**WATTS BAR NUCLEAR PLANT (WBN) UNIT 1 - TECHNICAL  
SPECIFICATION (TS) CHANGE NO. WBN-TS-01-12 - REACTOR COOLANT  
SYSTEM (RCS) SPECIFIC ACTIVITY**

PROPOSED TECHNICAL SPECIFICATION (TS) CHANGE WBN-TS-01-12  
DESCRIPTION AND EVALUATION OF THE PROPOSED CHANGE

PROPOSED TECHNICAL SPECIFICATION (TS) CHANGE WBN-TS-01-12  
MARKED PAGES

Figure 3.4.16-1 (page 1 of 1)  
Reactor Coolant DOSE EQUIVALENT I-131 Specific Activity  
Limit Versus Percent of RATED THERMAL POWER

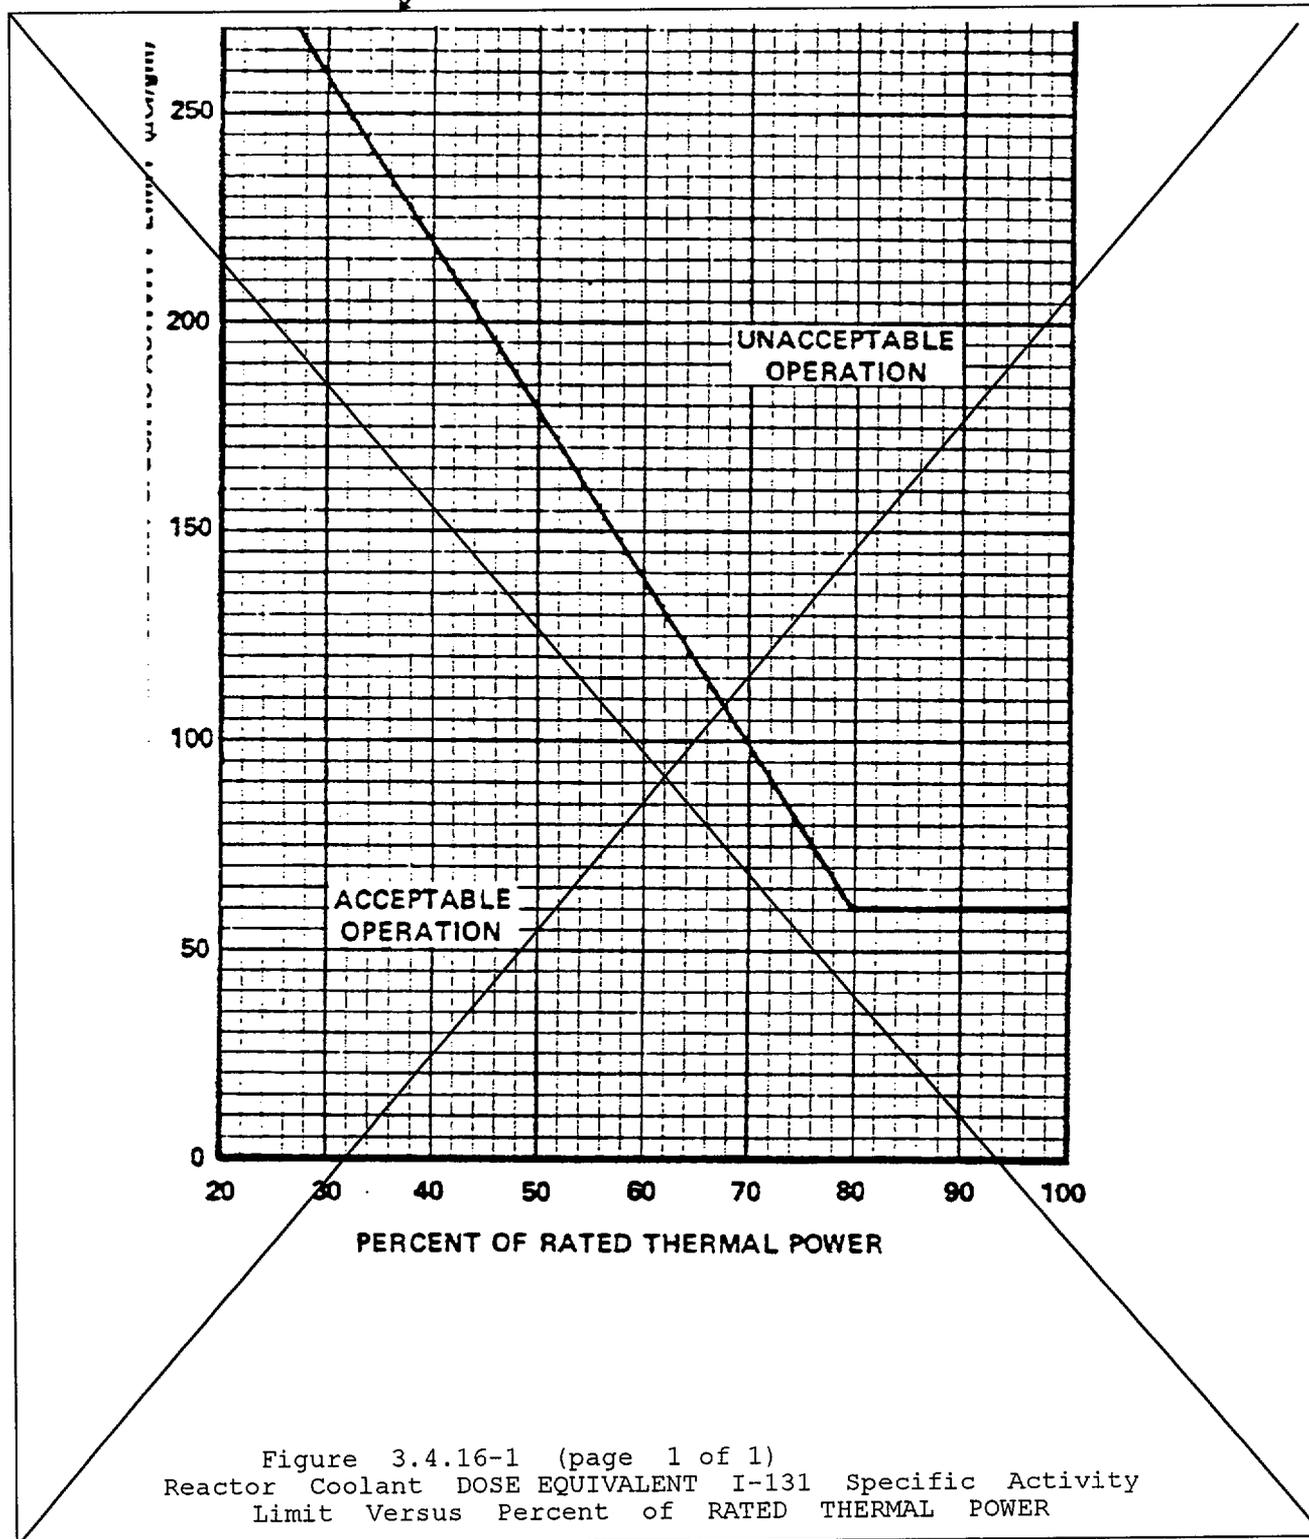
2. TS Section 3.4.16, Figure 3.4.16-1, "Reactor Coolant DOSE EQUIVALENT I-131 Specific Activity Limit Versus Percent of RATED THERMAL POWER," is being deleted and the maximum value of 21  $\mu\text{Ci/gm}$  DEI-131 is being added to TS Required Action 3.4.16.A and 3.4.16.C.

DELETE GRAPH
